Date: November 13, 2002  
 To: T10 Technical Committee  
 From: Alvin Cox (alvin.cox@seagate.com)  
 Subject: SAS internal cable configuration

The following revisions are made to define the SAS internal cable.

Figure xx SAS internal cable assembly and destination signal assignments

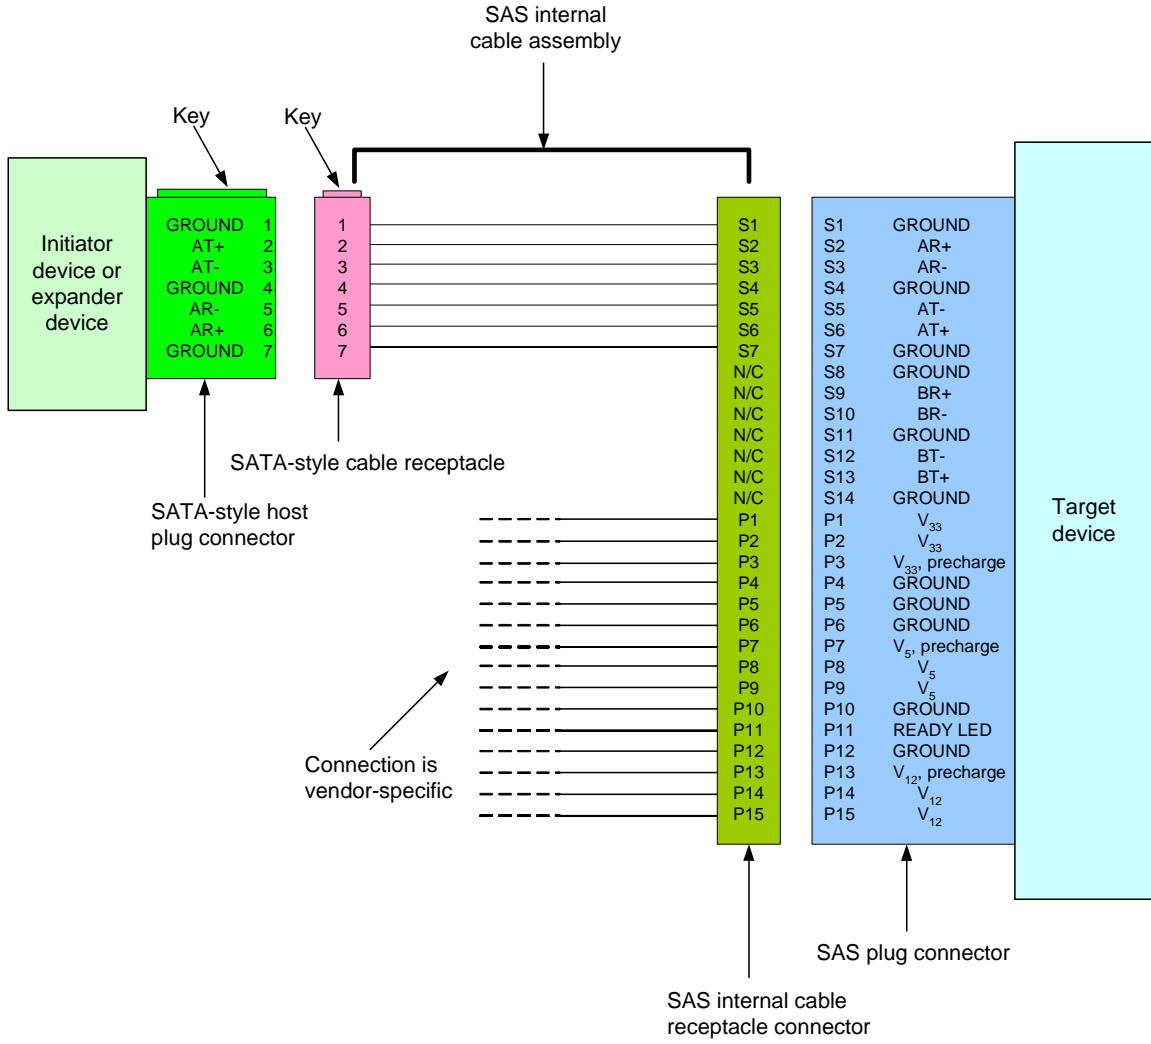
**(Editor's note: Replace existing text with the text and figure below.)**

SAS internal cables shall use the SAS internal cable receptacle connector on the target device end. A SATA-style cable receptacle shall be used for the physical link connection on the initiator device or expander device end. The power and READY LED signal connection is vendor-specific.

The SAS initiator device shall use a SATA-style host plug connector for connection to the SAS internal cable. The SATA host plug connector is defined in the SATA 1.0 specification. The signal assignment for the SAS initiator device or expander device with this connector shall be the same as defined for a SATA host in the SATA 1.0 specification.

Destination signal assignments and a connection diagram for the SAS internal cable are shown in figure xx.
